**LEESBURG BOARD OF ARCHITECTURAL REVIEW
STAFF REPORT**

SPECIAL PUBLIC HEARING AND WORK SESSION FOR COURTHOUSE SQUARE PROJECT: 25 JULY 2012

BAR Case No. THLP-2012-0040 Courthouse Square: Commercial Mixed-use Building on Loudoun Times Mirror property. Report #1 was June 4, 2012, Report #2 was June 27, 2012, and Report #3 was July 11, 2012

This is Report #4

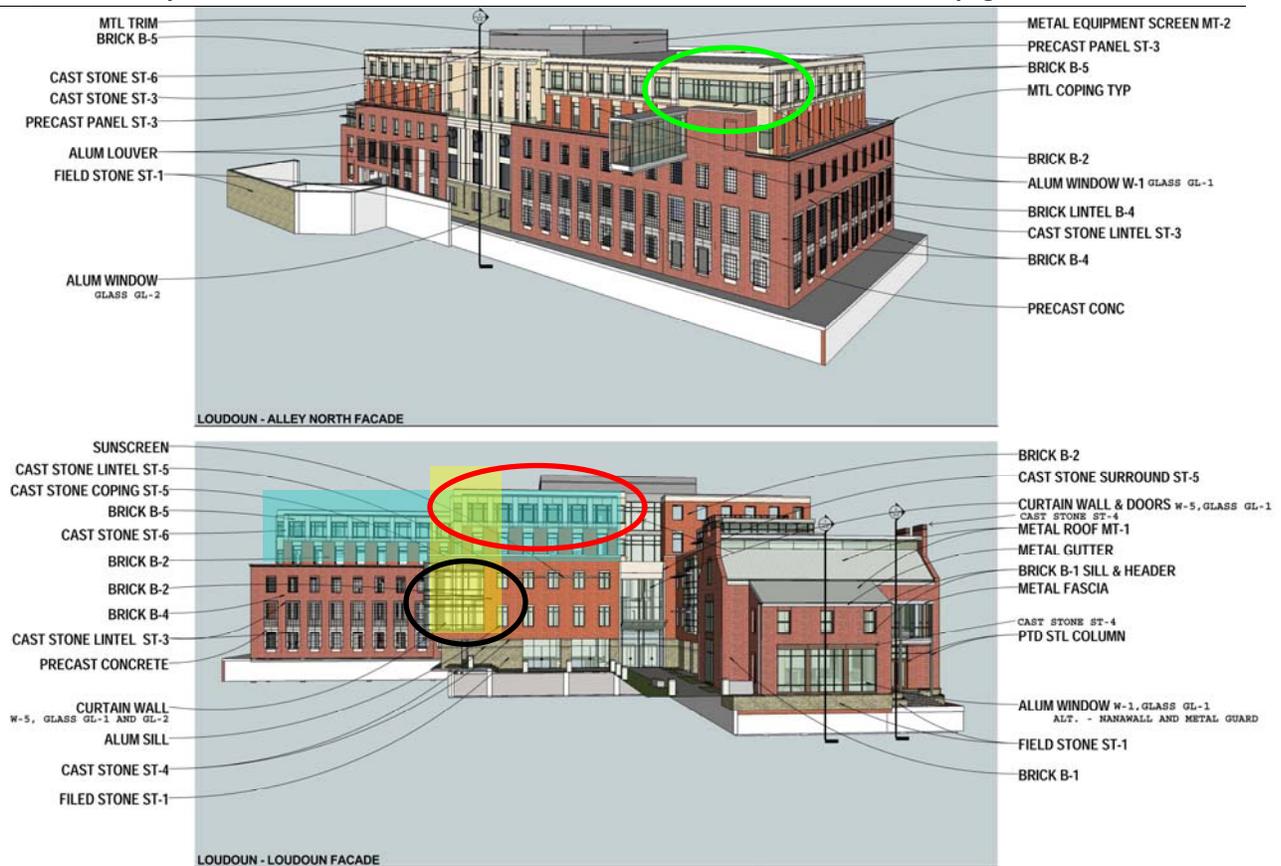
The Loudoun Street elevation has been broken into modules and the scale has been reduced. The exception is the top floor windows as they do not change in scale, materials or detail as the floors wrap from Loudoun to King to Loudoun to King and then Market—giving away the fact that this is one large building behind the row of historic buildings below and in front of it. The context that currently hides much of the view may not always exist and should not be counted on to hide the scale of the building.

This large unmodulated mass would be more consistent with the historic structures in the area by varying the wall planes and a more strategic use of different wall materials.

Fenestration and Curtain Wall

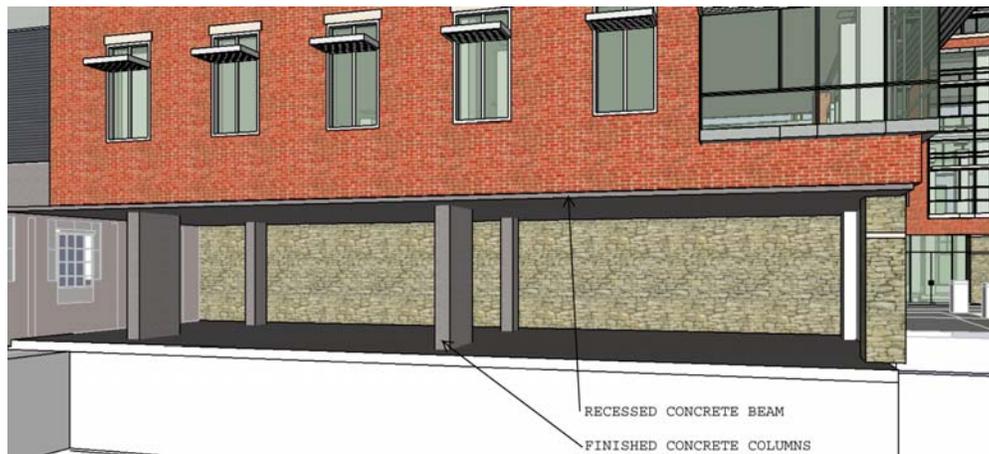
- **In green:** The altering of the fenestration pattern on the Market Street elevation successfully breaks down the massing and allows the column temple-like element to be centered, by giving an additive appearance to this corner without disrupting the rhythm of the façade.

- **In red:** The same alteration of fenestration moved to the Loudoun street elevation could do more to break down the massing and give the southernmost façade of Loudoun Street its own prominent character for pedestrians since this will be their main entry. Since this would mean a large expanse of glass, care should be taken in its placement rather than extending it for the whole floor. Wrapping the corners only or centering it could relieve some of the massiveness.

- **In black:** While the guidelines do not specify materials or deny them outright, their suitability as compatible with traditional materials requires a closer look at the use of a curtain wall over a two story high section of the building which wraps the corner from Loudoun to King Street. Ch. VII M 2. "Size details and related features so that their scale respects classical proportions as exhibited on historic structures through the district". The use of such a large piece of curtain wall should be discussed as to how much, if any, of it is appropriate in this form. Previously, the breakdown of framing for the glass had been discussed by the board, but it was unclear at that time that a curtain wall system would be used. Storefront framing has been used in commercial buildings for some time; however, curtain walls may be considered glass walls, as opposed to windows, making their proportion to solid wall surfaces important.

Structure over parking as discussed in July 11, 2012 meeting:

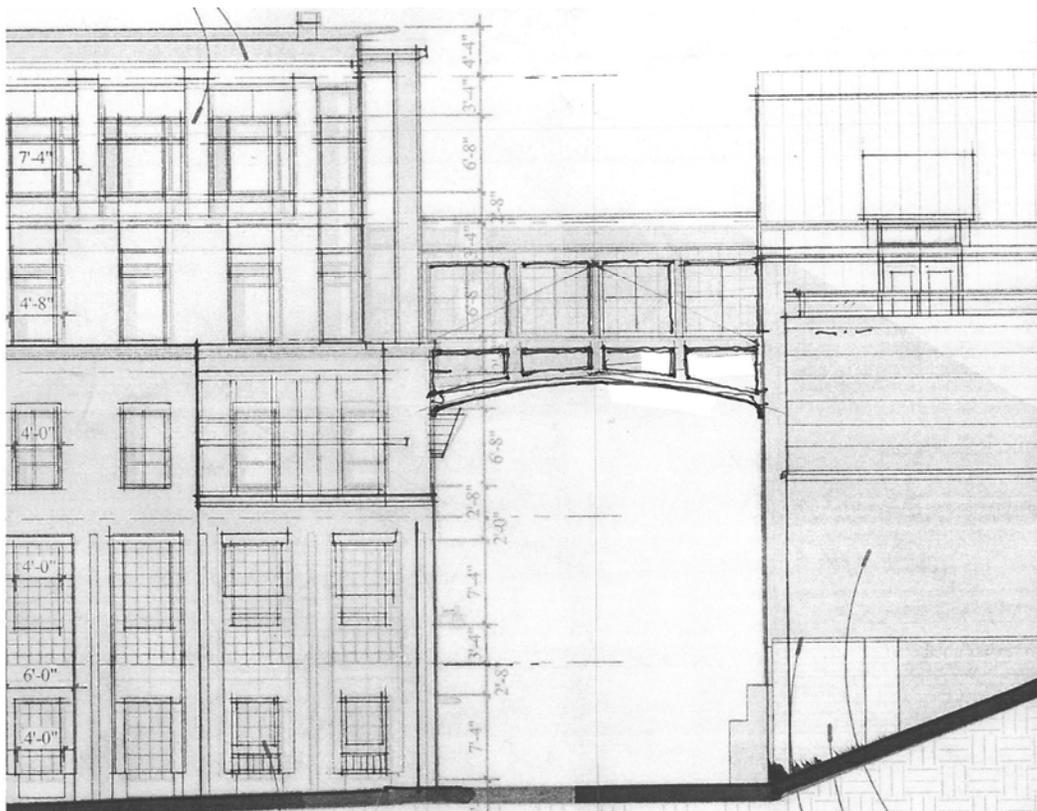
Questions over the “floating bricks” and the use of plain concrete columns like utilitarian parking garages have been answered with the solution provided above by the architects. The concrete structure is now showing and the concrete columns will be shaped and finished in the same manner as the exposed structure.

Pedestrian bridge from LTM to new construction in sketch shown above:

The addition of the structural steel arch is appropriate and recalls historic steel bridges, some of which are still used locally.
